Addendum No. 1

REBID TRUCKEE CANYON WATER SYSTEM EXPANSION

PWP Bid No. WA-2016-158

May 31, 2016

SHEET NUMBER
E051
 43 OF 53

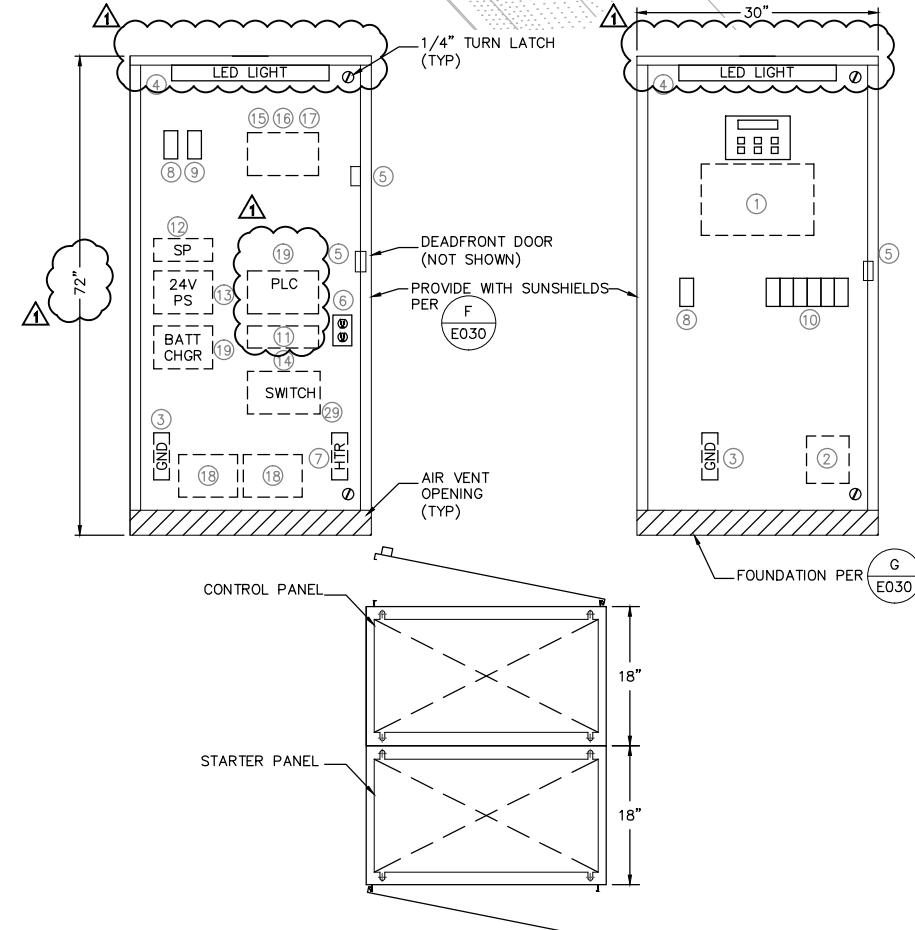
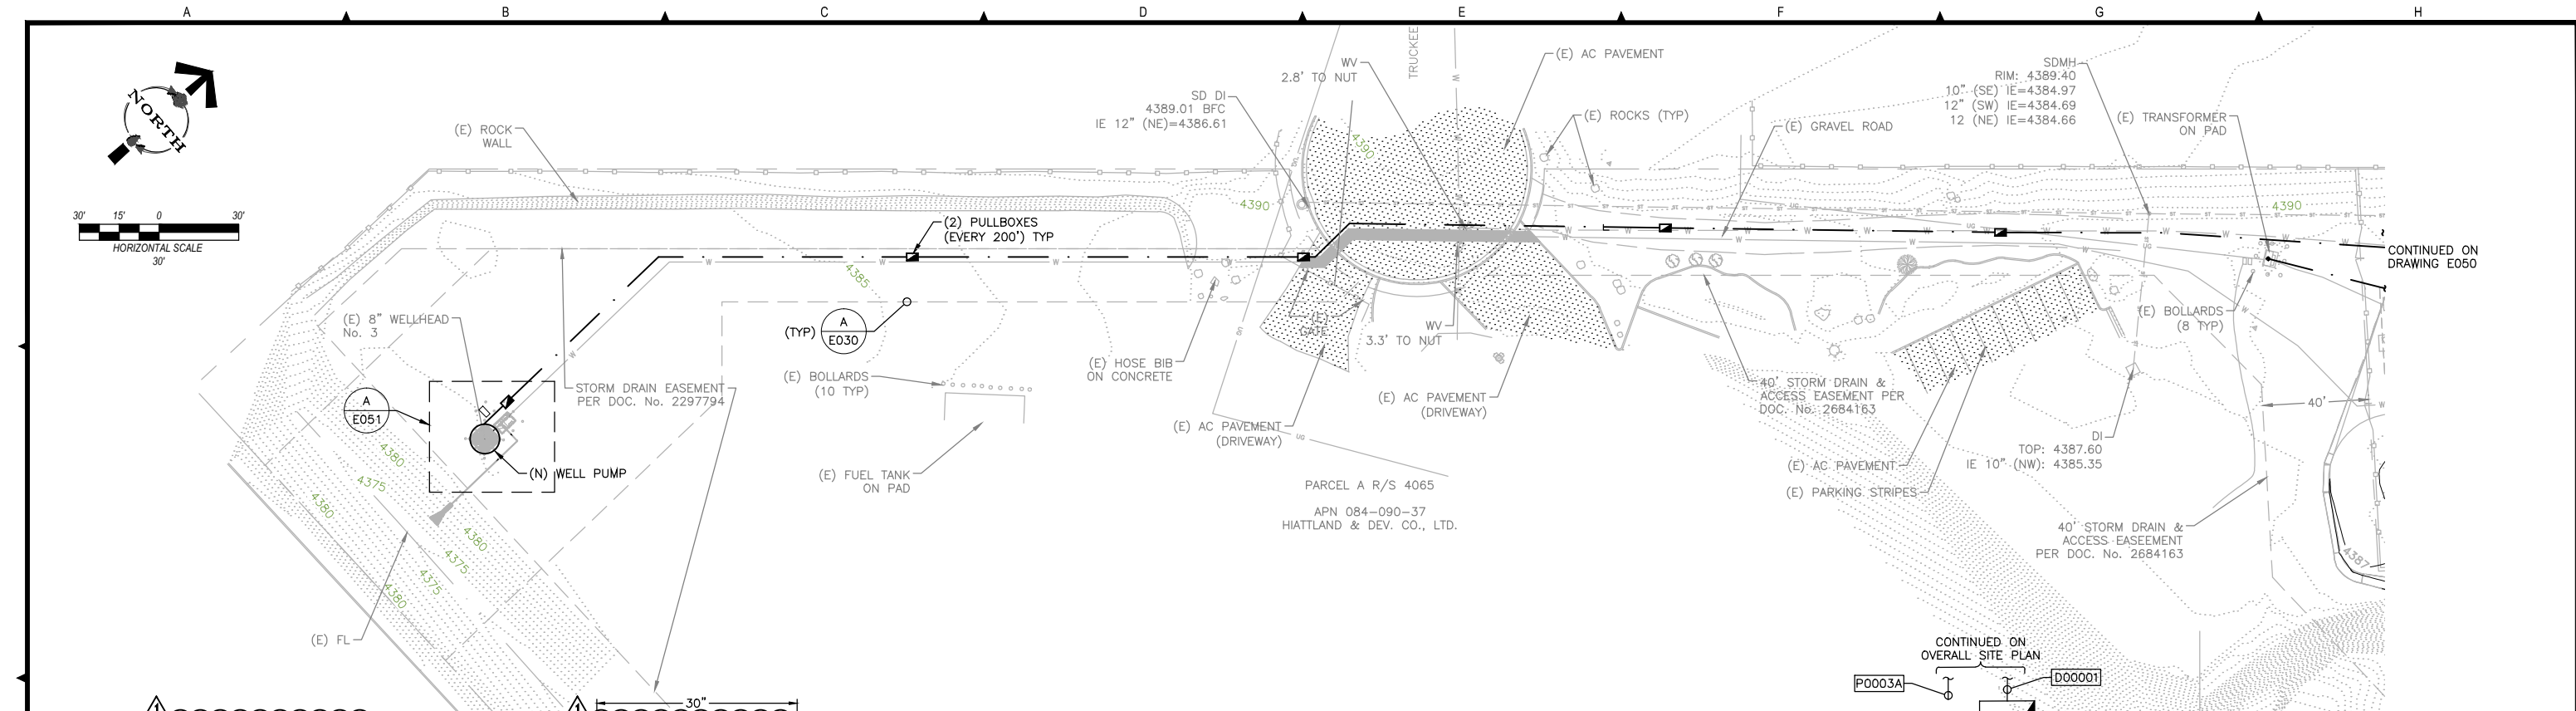
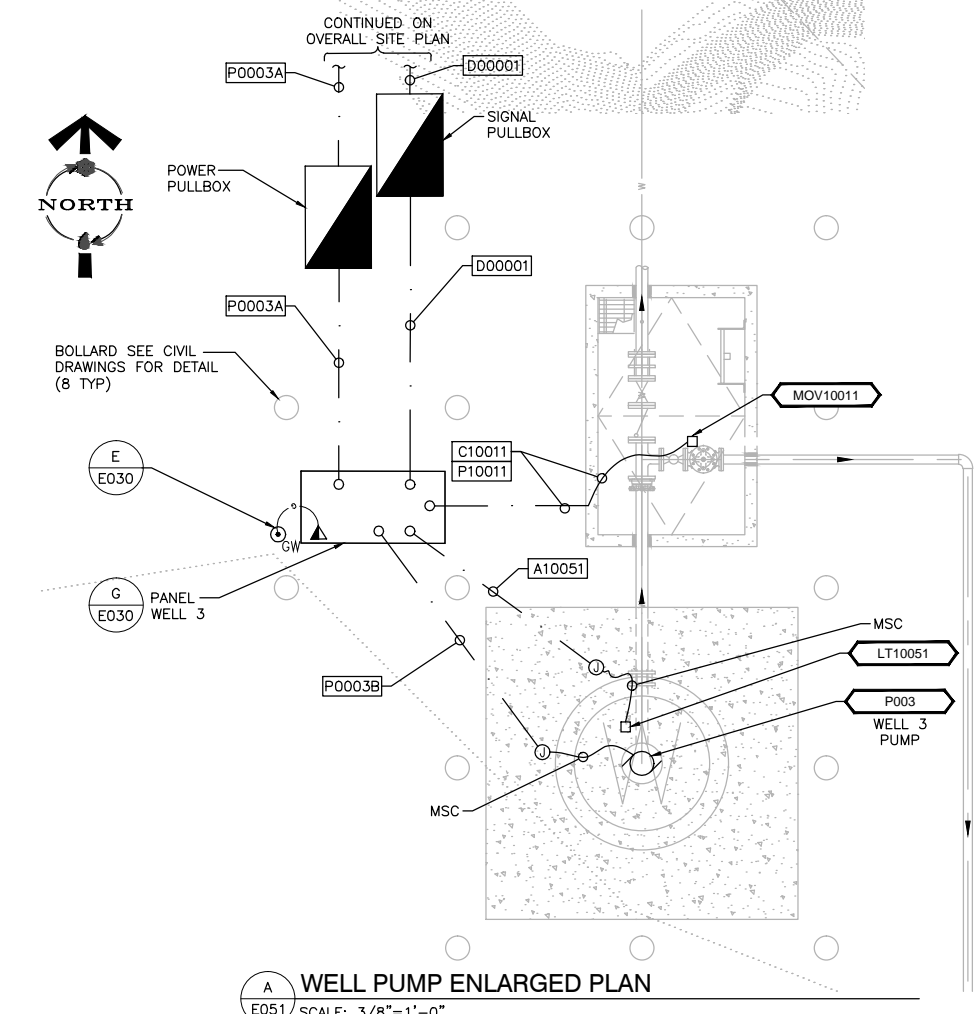
Sheet Number	Page(s)	Description of amendment
M101	27	Please see attached M101 for changes to the booster pump manifold including the addition of pressure gauge taps and eccentric reducers on the suction side of the booster pumps.
M104	30	Please see attached M10 for changes to the booster pump manifold including the installation of eccentric reducers on the suction side of the booster pumps.
E002	36	Manual transfer switch replaced with automatic transfer switch. Please see attached E002 for automatic transfer switch model.
E030	40	The enclosure specified in note 2 of detail B/E030 shall be rated for 600A.
E050	42	Please see attached E050 for the location of the 600A meter main panel.
E051	43	Please see attached E051 for changes to the control panel, starter panel and bill of materials.

NOTE:
 1. TMWA TO CONFIRM FINAL BILL OF MATERIALS. COORDINATE WITH TMWA FOR ADDITIONAL REQUIREMENT.
 2. PANELS TO BE SAGINAW #SCE-72EL3018FS OR APPROVED EQUAL.
 3. PANELS SHALL BE POWDER COATED WHITE COLOR.
 4. PROVIDE DOORS WITH PAD LOCKABLE HANDLES.
